**SERVICE CHANGE NOTICE**

ASSY.# 701-0194/(1672)      DATE 10-8-86      SCN# 002

TITLE: 29B FILTER BOARD

REASON FOR CHANGE: TO CORRECT A LONG TERM PROBLEM WITH SECONDARY FUSES  
BLOWING. THIS CHANGE APPLIES TO BOTH THE OLDER (701-1672) AND NEWER  
(701-0194) FILTER BOARDS.

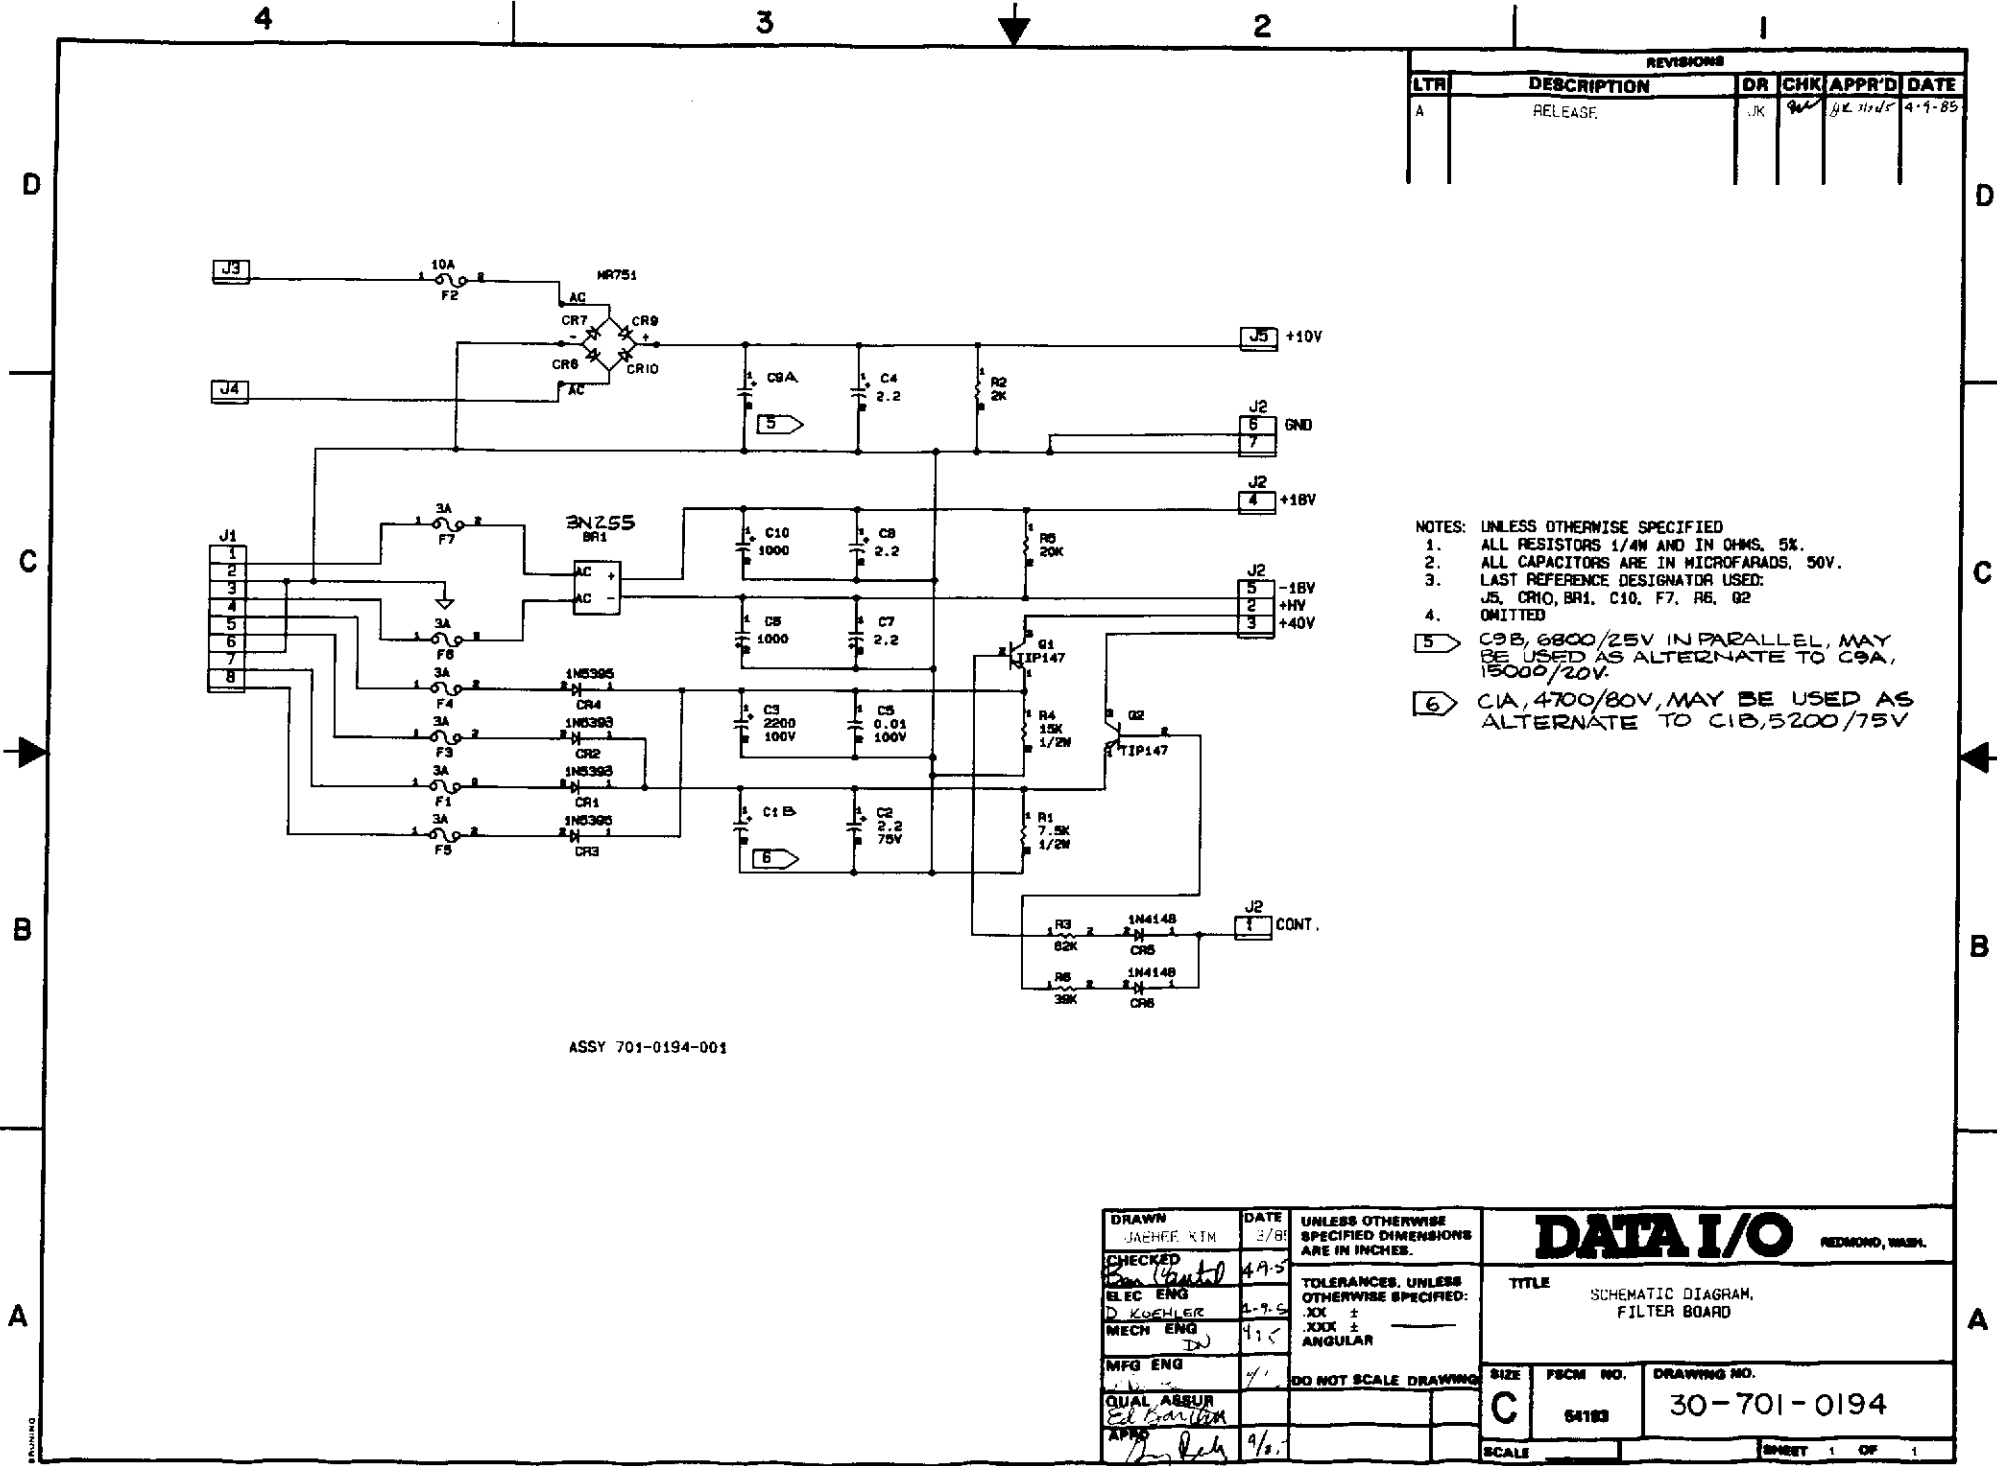
BEFORE	AFTER
BOARD	701-0194-001	701-0194-002
PWB	410-0230-001	410-0230-002
	FUSE F2 = 10A	F2 = SHORT
	FUSES F1, 3, 4, 5 = 3A	F1, 3, 4, 5 = SHORT
	FUSE F6 & F7 = 3A	FUSE F6 & F7 = 5A (416-3050)
SCHEMATIC	30-701-0194-001	30-701-0194-002

REMOVE F1 THRU F7 FROM FILTER BOARD. ADD JUMPER WIRES; PERFORMED INSULATED, P.N. 4020013-60 TO LOCATIONS F1, F2, F3, F4, and F5. IN LOCATIONS F6 and F7 REPLACE WITH; P.N. 416 3050, FUSE 5A, 125V, FAST BLOW. REMARK BOARD 701 0194 002. CRG UNITS TO HAVE NEW 701 0194 INSTALLED.

FIGURE 4

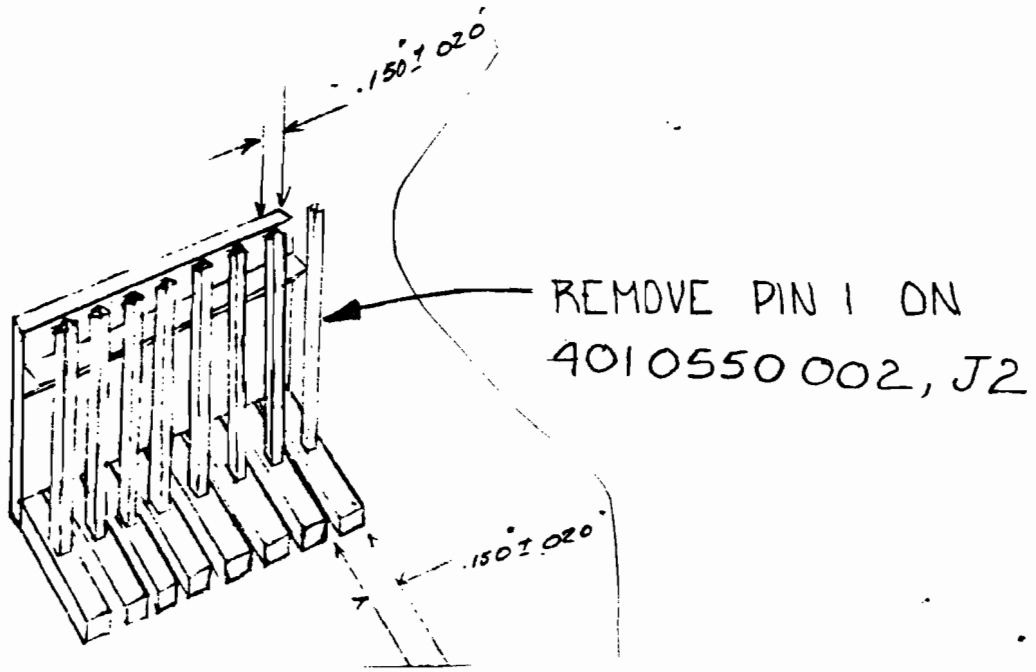
Assy Affected:	Approvals	Date	Distr.
750-1516-003 B3	MEll Barrow	4/17/85	PC
701-1672-009 B1	PE Willie Kuhn	4/17/85	ME
	QA James Nether	4/17/85	CRQ
			GM
			APPL
Op #	Assy P/N	THIS REWORK WILL BE DONE TO THE 750-1516-003 LEVEL	
		NOTES: 1) THIS REWORK APPLIES TO 701-1672-009 USING	
		410-1678-002 B ONLY	
		2) PERFORM ALL REWORK PER DATA I.O. WORKMANSHIP	
		MANUAL	
10	701-1672-009	CUT HEADER BODY OF 4010550002 AND REMOVE PIN SHOWN IN FIGURE 4.	
20		INSTALL 709-0190-001 SHOWN IN FIGURE 5	
30		RE-LABEL AS 701 1672 013 B2	
40		RE-LABEL AS 750 1516 004

FIGURE 6

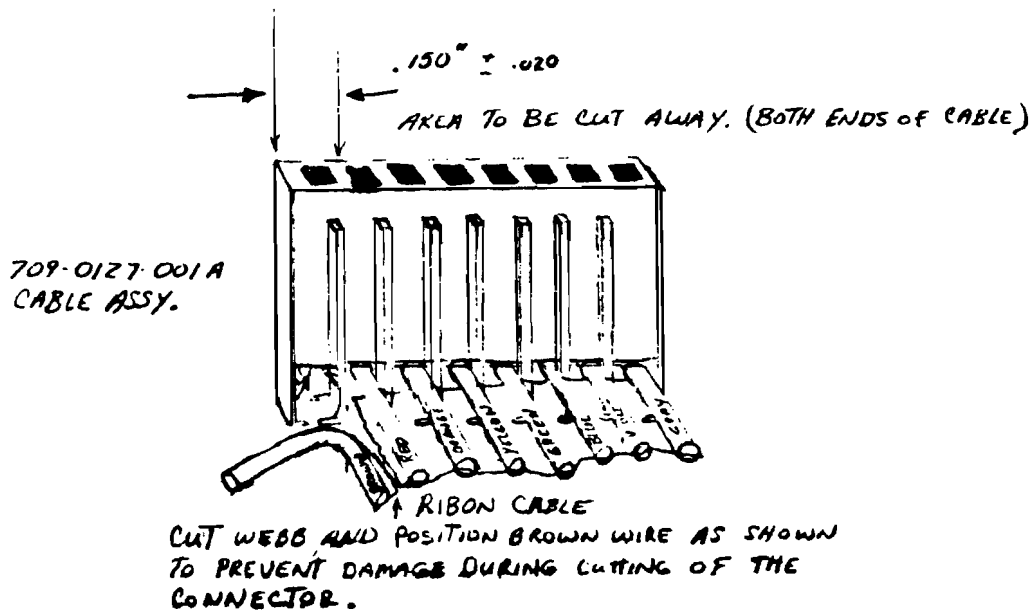
Op #	Assy P/N	ME	Apprvals	Date	Distr.
		ME <u>Ell Barone</u>		4/17/85	PC
		PE <u>John Kordy</u>		4/17/85	ME
		QA <u>James Tucker</u>		4/17/85	CRO
					CM
					APPL
		NOTES: 1) THIS REWORK APPLIES TO 709-DICT-001 ONLY			
		2) PERFORM ALL REWORK PER DATA I.O. WORKMANSHIP STANDARDS.			
10	709-DICT-001	MAKE A 1/2" CUT IN THE WEBBING BETWEEN THE RED AND BROWN WIRES (FROM THE CONNECTOR, BOTH ENDS).			
20		CUT AWAY .150" ± .020" THAT PART OF THE CONNECTOR COMMON TO THE BROWN WIRE. NOTE: BEFORE CUTTING REMOVE THE BROWN WIRE AS SHOWN IN FIGURE 6.			
30		STRIP AND CRIMP FEMALE TERMINALS 401-015 AT BOTH ENDS OF BROWN WIRE AS SHOWN IN FIGURE 7.			
40		RE-LABEL AS 709-DICT-002

TITLE: Filter Board

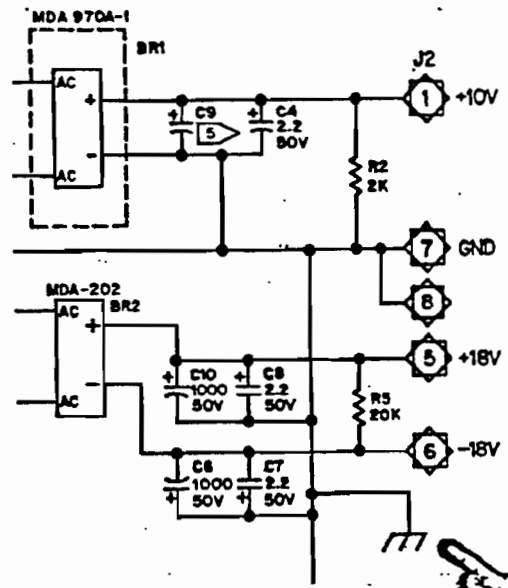
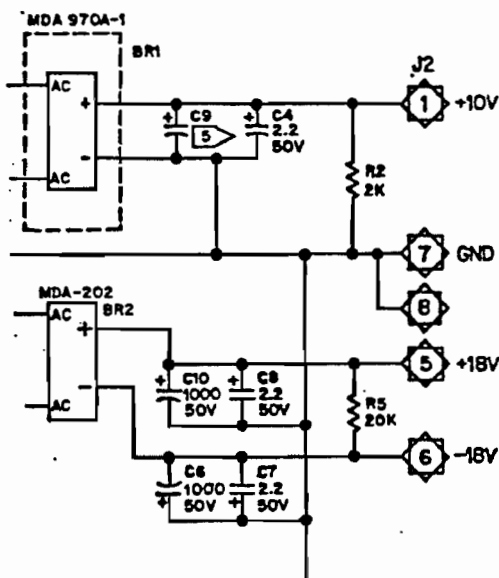
REASON FOR CHANGE: To connect circuit ground to chassis ground.

COMMENTS: Connect a Jumper wire from circuit ground near C8 to the nearest mounting screw per the attached instructions. See 701-0047 SCN#001 and 990-0013 SCN#002 for additional rework.

Op #	Assy P/N	(408-1266)	(402-0012)
1	701-1672	Attach a 2" green #18 wire w/ ring lug to the ground plane at the lower right corner of the PWA	
		To remove the mask, bread the surface near the center of the area to be cleared. Apply heat and solder with gentle iron pressure and the mask will boil off.	
		See page 9 for drawing.
